## **WORKING DRAFT OF NEC CODE-MAKING** **PANEL 2 MEETING OUTPUT**

**Document: National Electrical Code®**

**Revision Cycle: A2025**

**Meeting Dates: January 15 - 20, 2024**

**Figure 210.52(C)(1) Determination of Area Behind a Range, Counter-Mounted Cooking Unit, or Sink.**

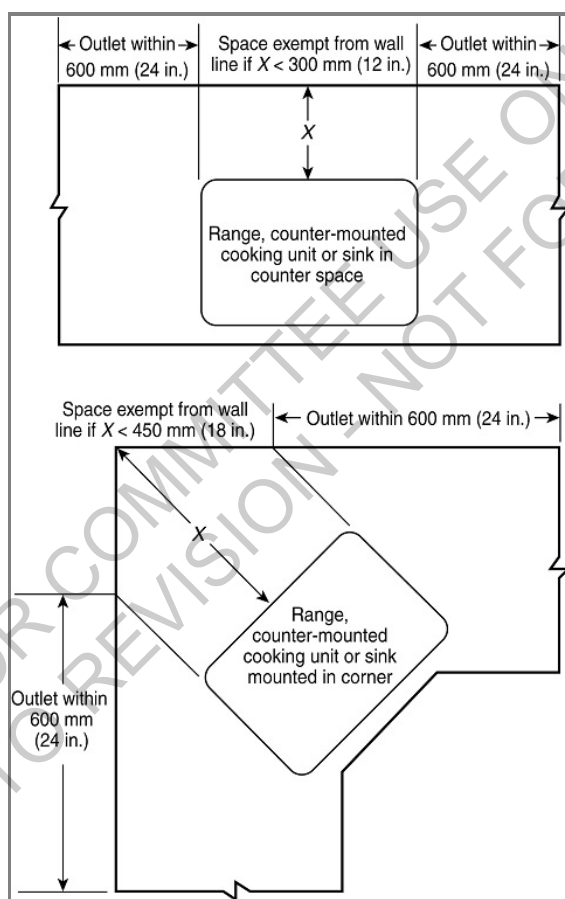
**Committee Statement:** CMP 2 reaffirms receptacle outlets are not required to be installed at island and peninsular countertops and work surfaces. Such locations may be designed where the requirements in 210.52(C)(3) and (4) cannot be met. The requirement for “future provisions” is also retained as certain construction methods may not allow receptacle outlet that meet the requirements of 210.52(C)(3) and (4) to be added at a later date. 210.52(C)(4) has been added to clarify as to where receptacle outlets can and cannot be installed, at new construction or a future date.

### **Figure D14(a) Monitoring Controlled and Non-Controlled Loads, 50 A EVSE.**

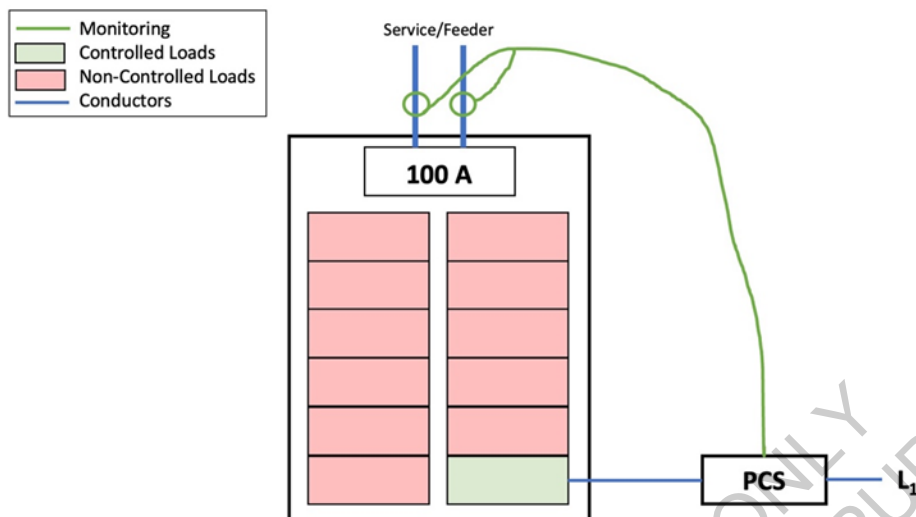
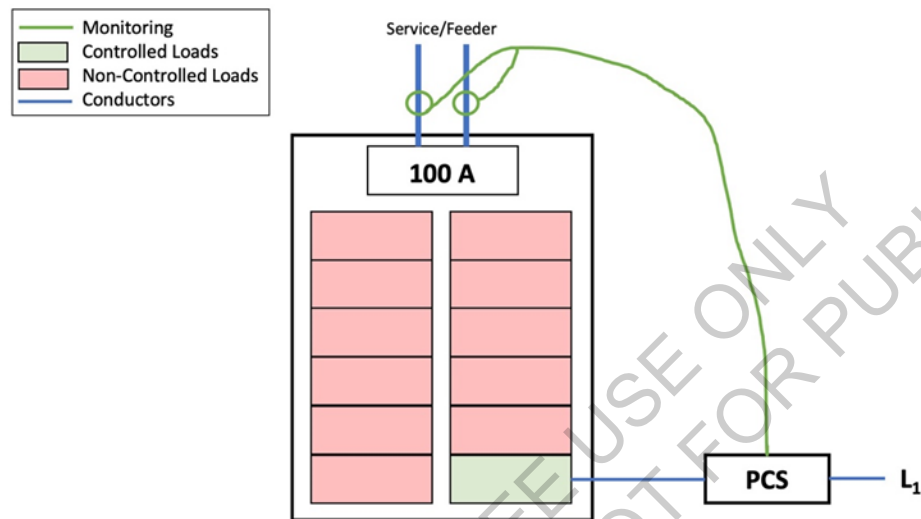
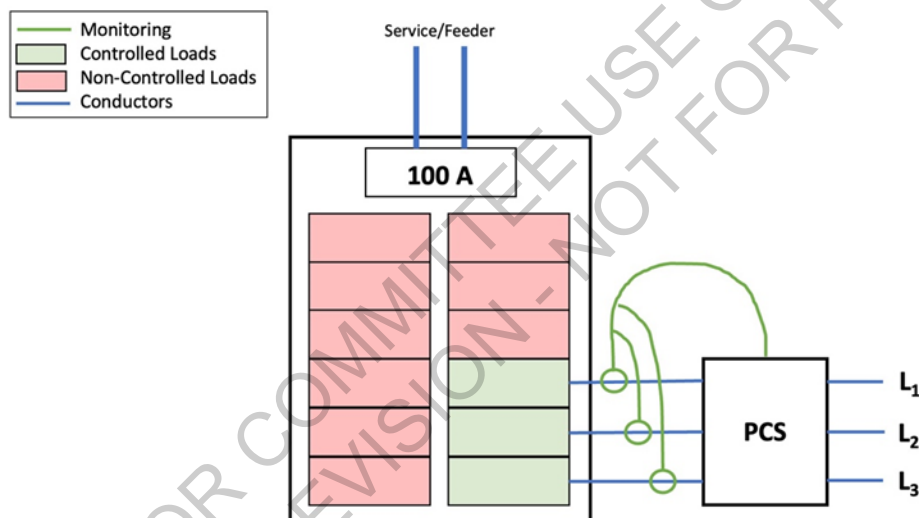
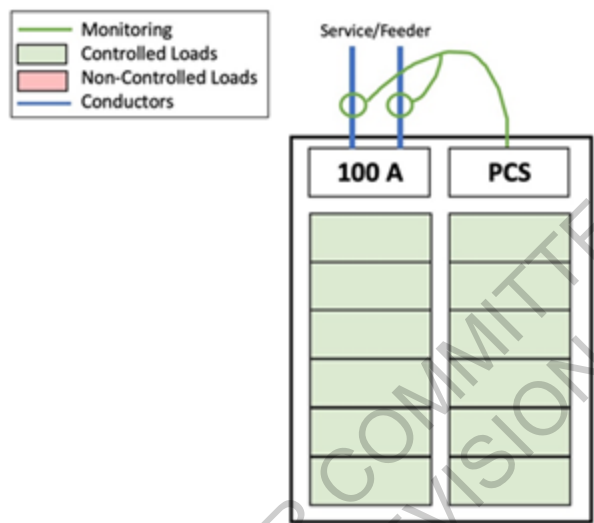
**Committee Statement:** Four examples are added to Annex D to aid in the application of the requirements related to Power Control Systems (PCS) included in the Section 220.7 (formerly 220.70). As a new provision in the Code, with multiple options, these examples are intended to ensure clear understanding of the requirement.
